Amendment Under 37 C.F.R. § 1.114(c)
U.S. Application No. 10/510,109

Attorney Docket No.: Q83563

AMENDMENTS TO THE DRAWINGS

Fig.3

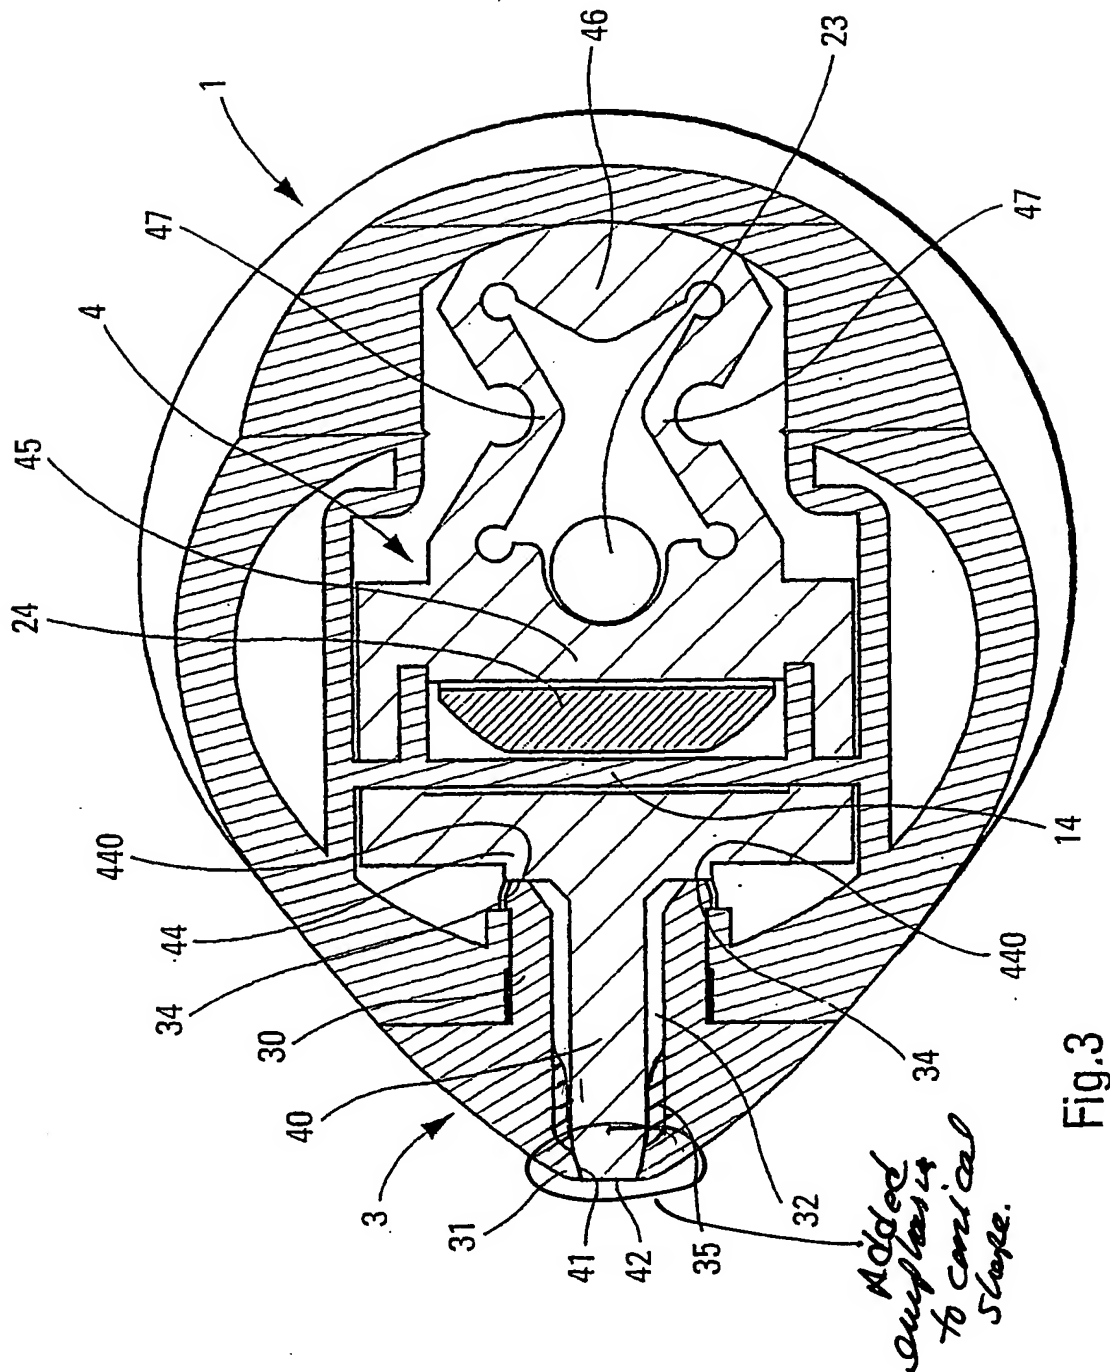
Figure 3 is amended to show the plunger pin consistently with its depiction in Fig. 1.

Fig. 4

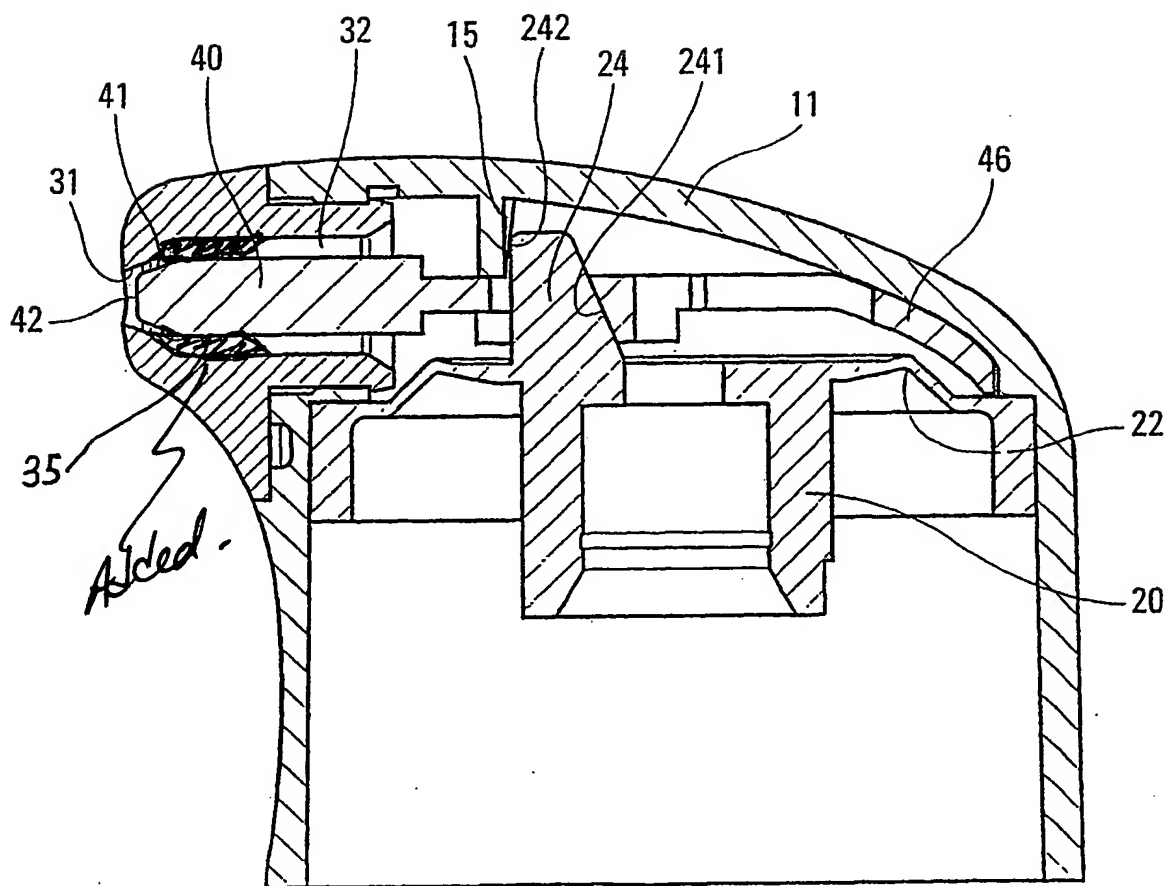
Figure 4 is amendment to show the splines.
